**ADDENDUM NO. 1**

Project: **STEPHENSON SCHOOL BUILDING & PARKING IMPROVEMENTS**

Owner: **City of Dripping Springs, Texas**

Date: **July 8, 2025**

A6.01

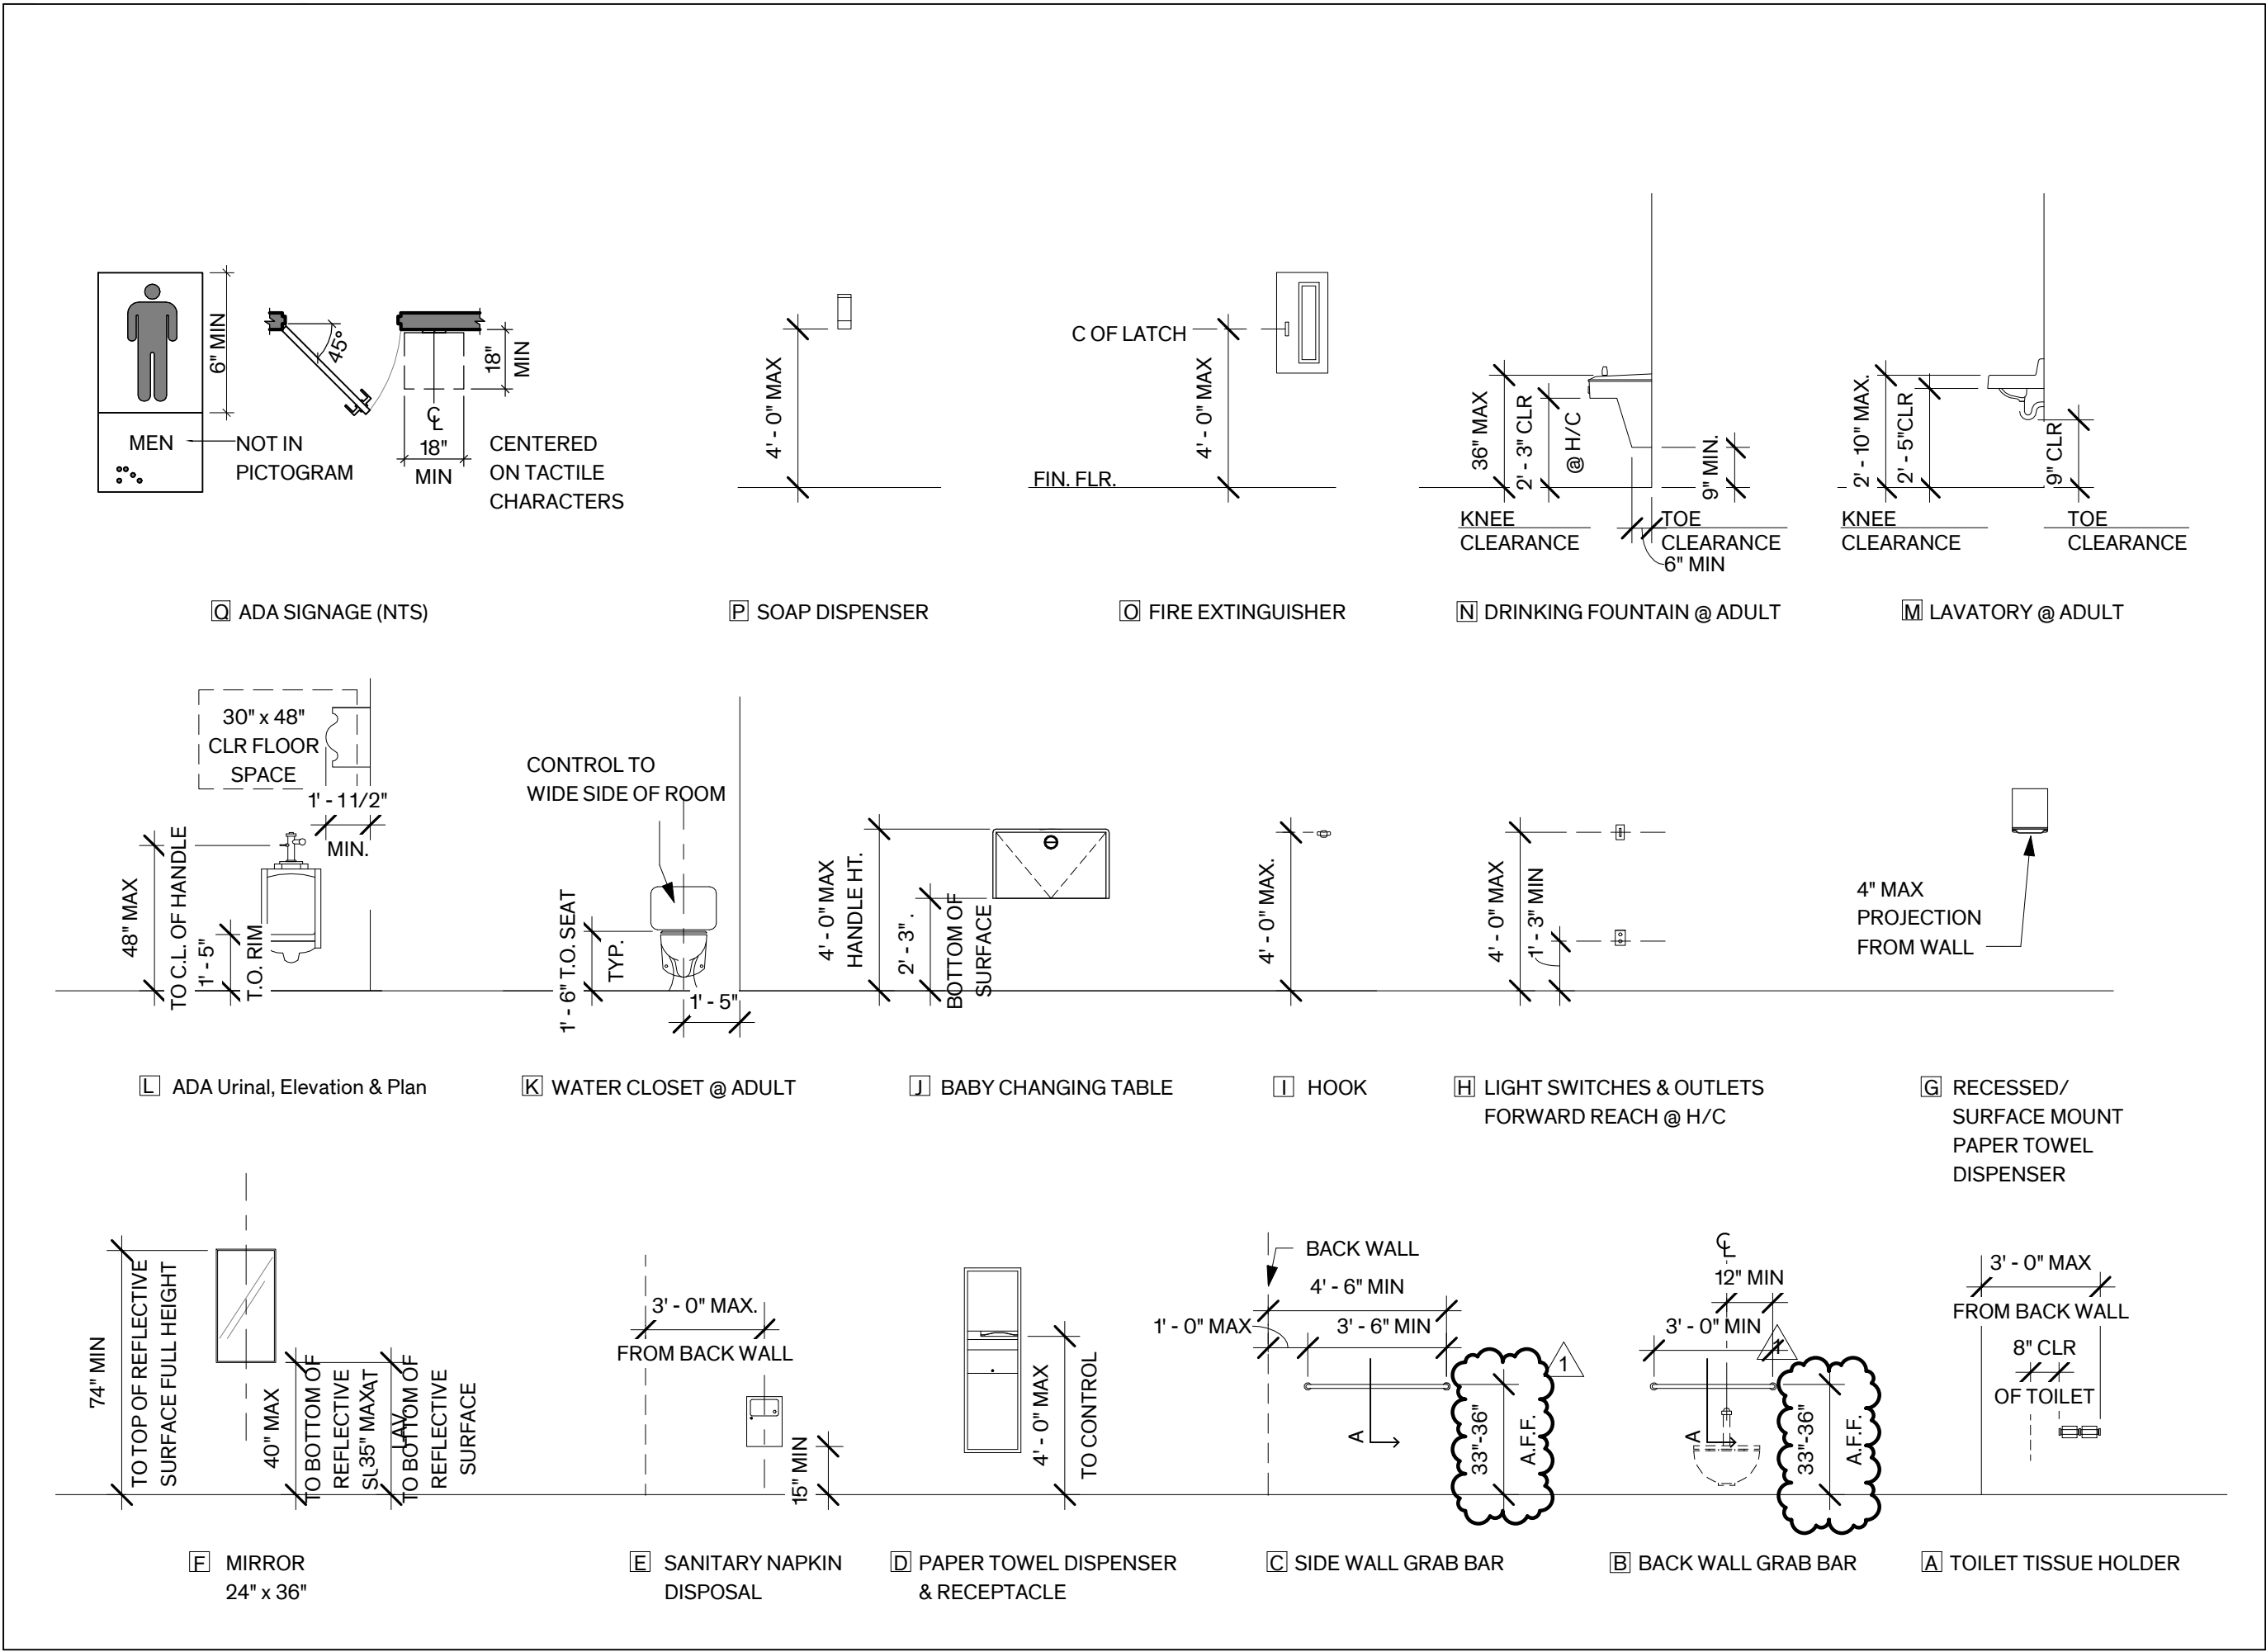
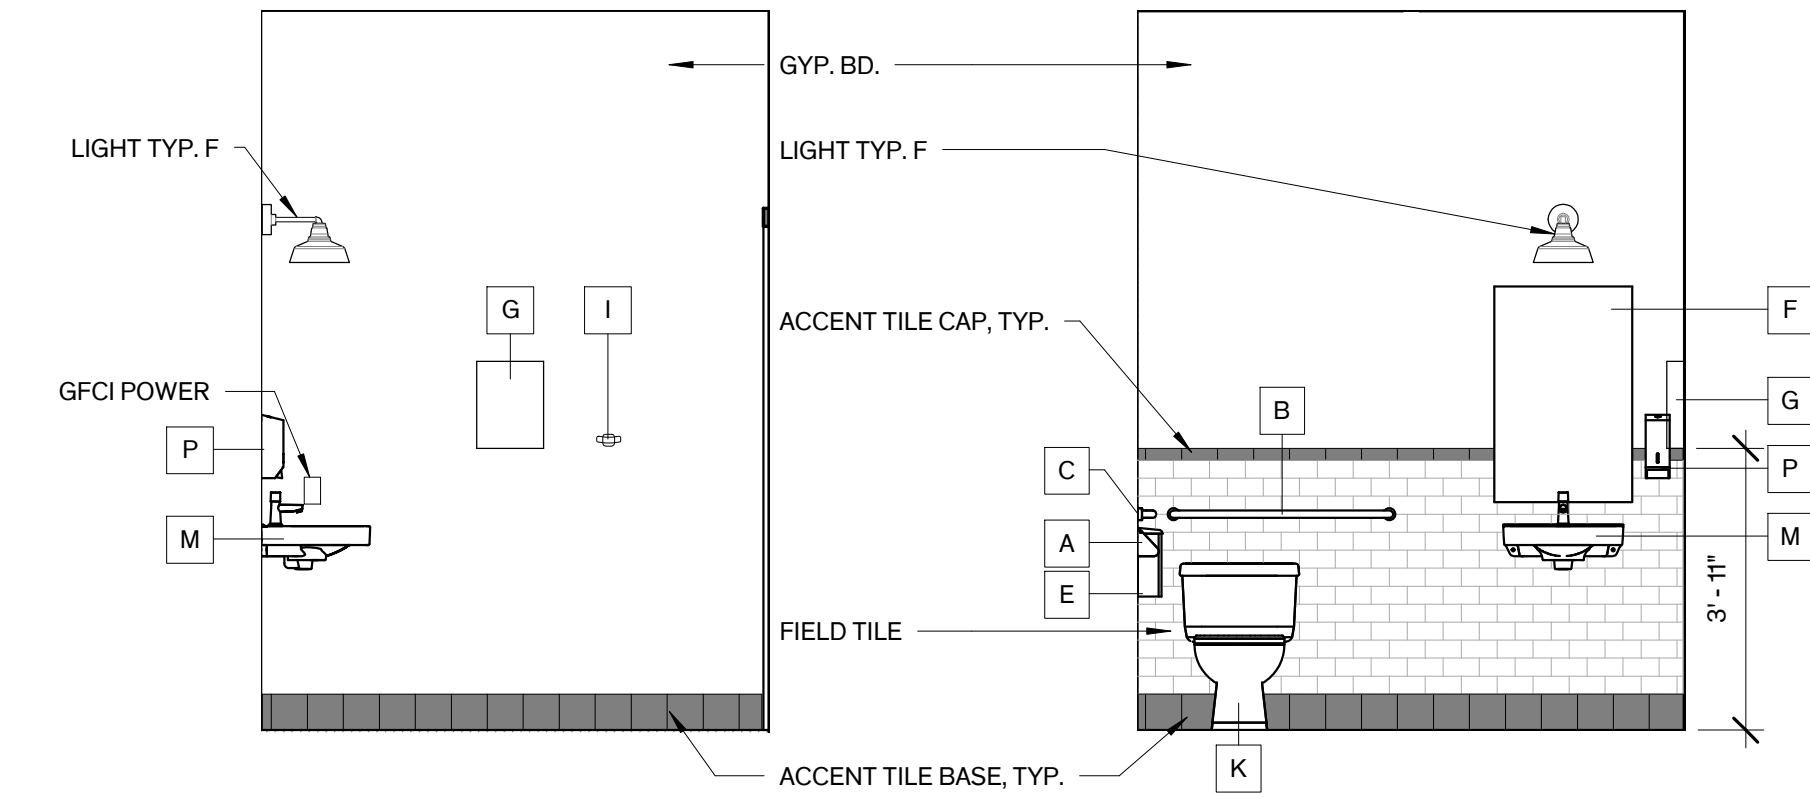
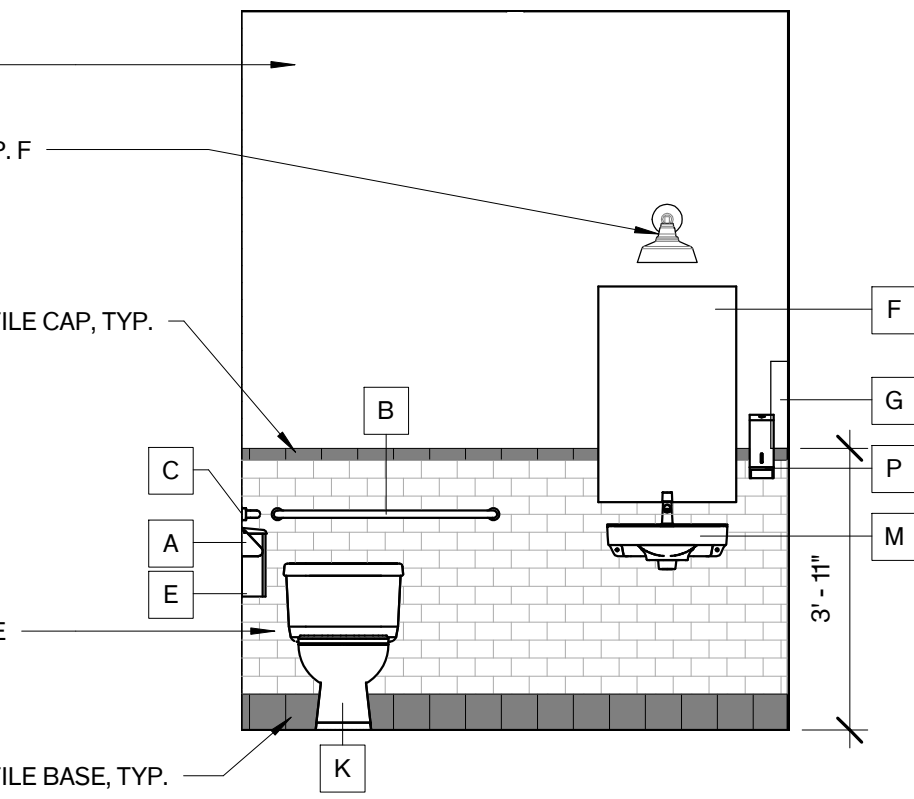
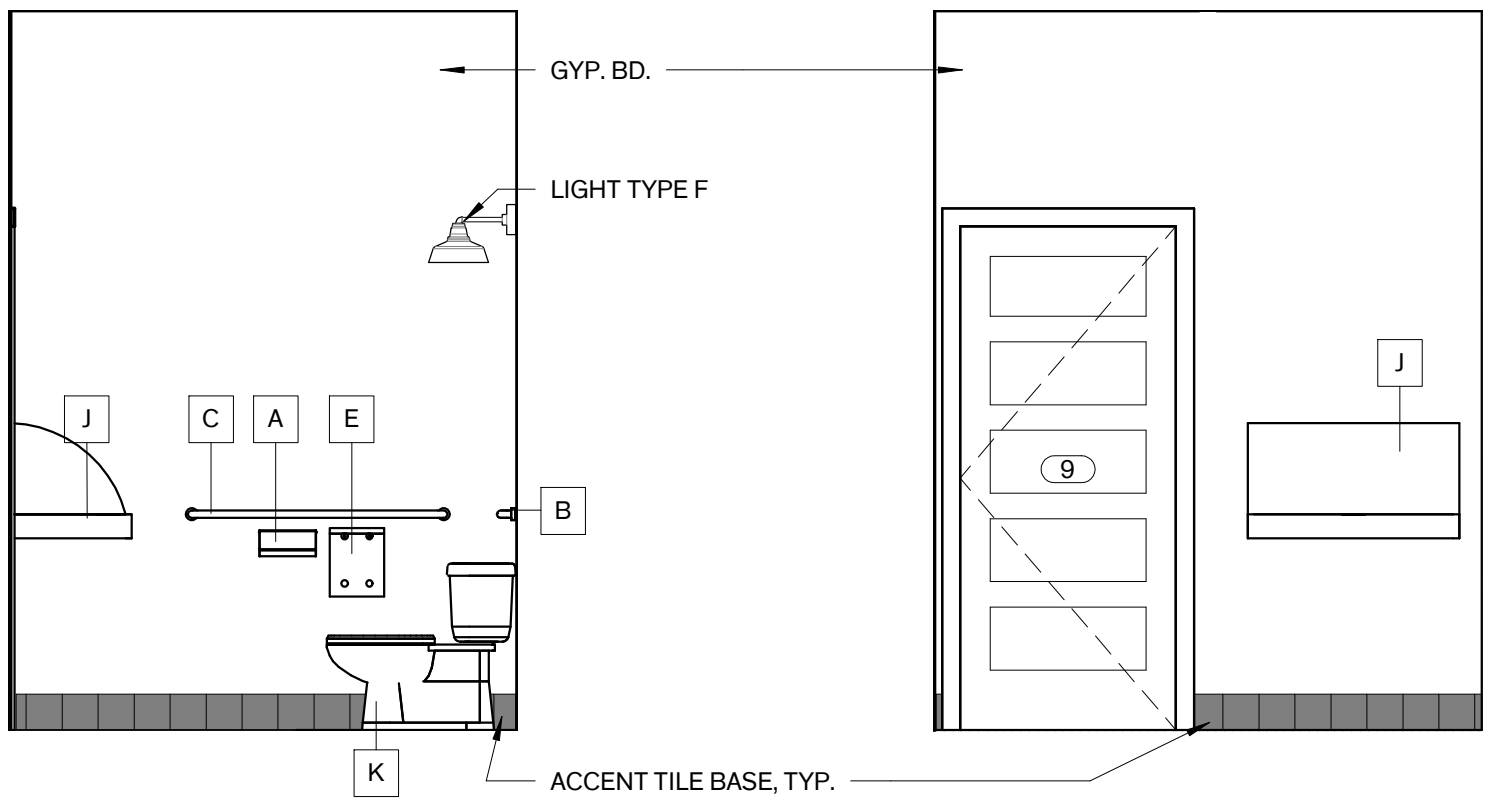
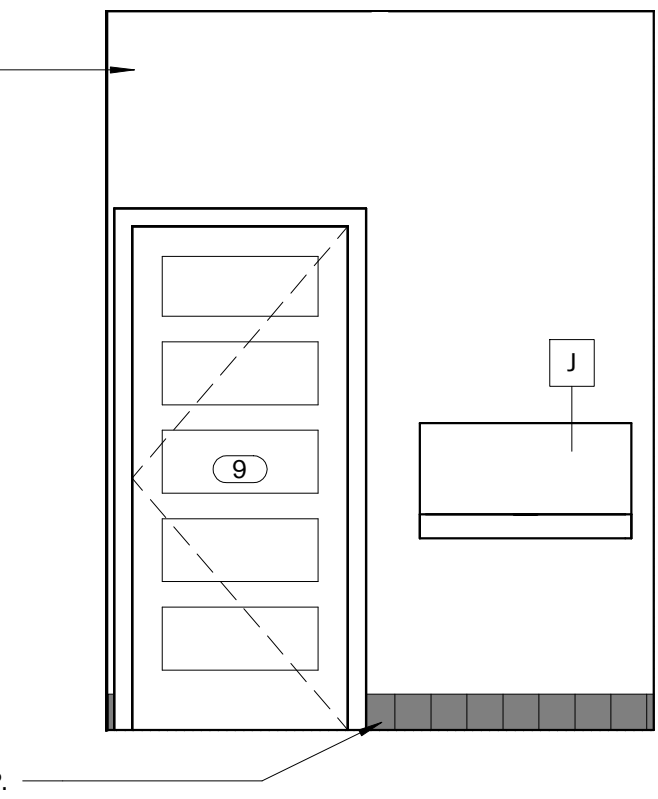
UPDATE – Provide TAS handrail mounting height range in ADA legend.
